job COED DARCY	
title REVISED MASTERPLAN	
date DEC 2010	scale 1:2500 @ A0
 ST.MODWEN	
Sir Stanley Clarke House 7 Ridgeway Quinton Business Park Birmingham, B32 1AF	
Masterplan produced by Alan Baxter, 75 Cowcross Street, London, EC1M 6EL tel: 020 7250 1555 email: aba@alanbaxter.co.uk www.alanbaxter.co.uk Base artwork produced by Lear Associates	
drg. no. 1332/400/MP/SK/TERT	rev. H

This RRWCC has been prepared for Phase 28 in response to the receipt of a written request from SMD pursuant to clause 4.3 of the RMA. The Phase Boundary and Intended Use on which this RRWCC is based were notified to the Monitor by letter, a copy of which is provided in **Appendi A**.

Contract Name: Coed D'Arcy **O** **ITOR** RFI No:
Contract Number: GNP/NJR/13773-2 Date Raised: 21/3/2011
Subject: Commercial Area Proposed Site Investigation
To: Mark Williams Atkins
From: Simon Gibbons / Simon Cole URS

Contract Name: Coed Darcy Monitor RFI No:
Contract Number: GNP/NJR/13773-2 Date Raised: December 2014
Subject: Review of Atkins' Commercial Area Validation Report 5041216-PLOTS-RPT-001016 dated September 2014
To: Michelle Lee Atkins
Cc: Mike Poland Atkins
From: Rhys Mander/Joanne Foy URS

Figure Location plan

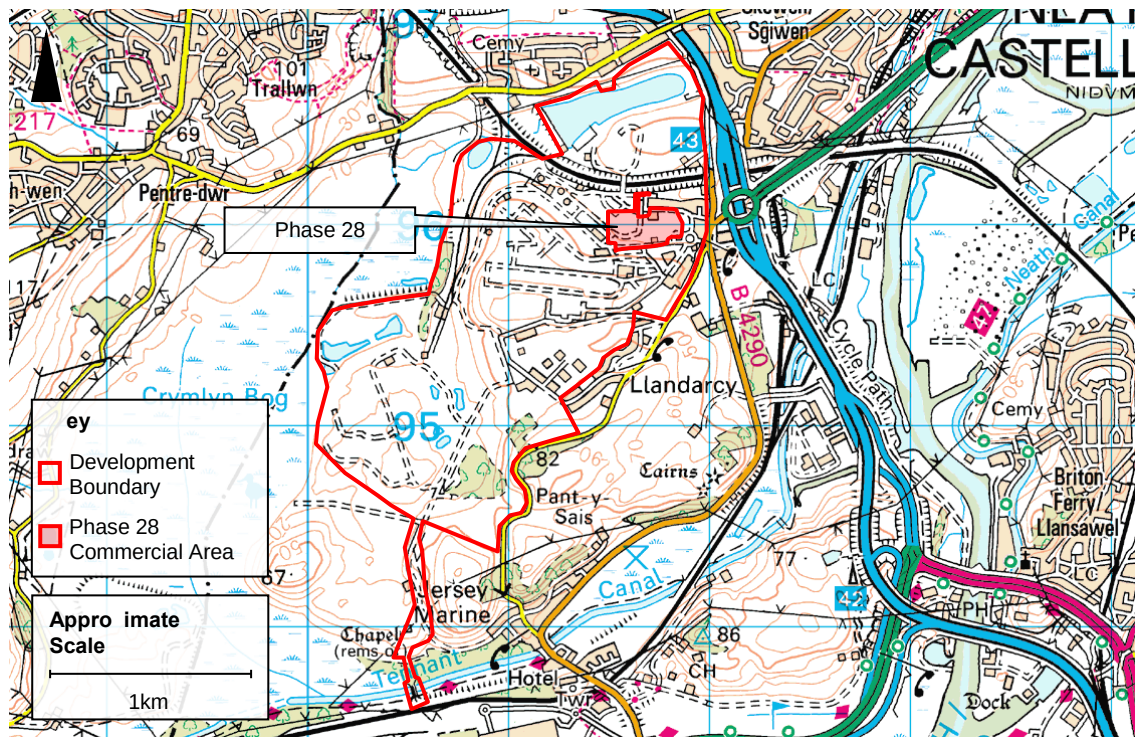
It is noted that the masterplan indicates some residential development within the phase boundary. Depending on the nature of this residential development further remediation works may be required given that this certificate has been prepared for a commercial end use. If however the proposed residential development were to comprise living spaces from the first-floor upwards (for example flats above shops) with no ground floor residential areas and no gardens, then this certificate could remain valid.
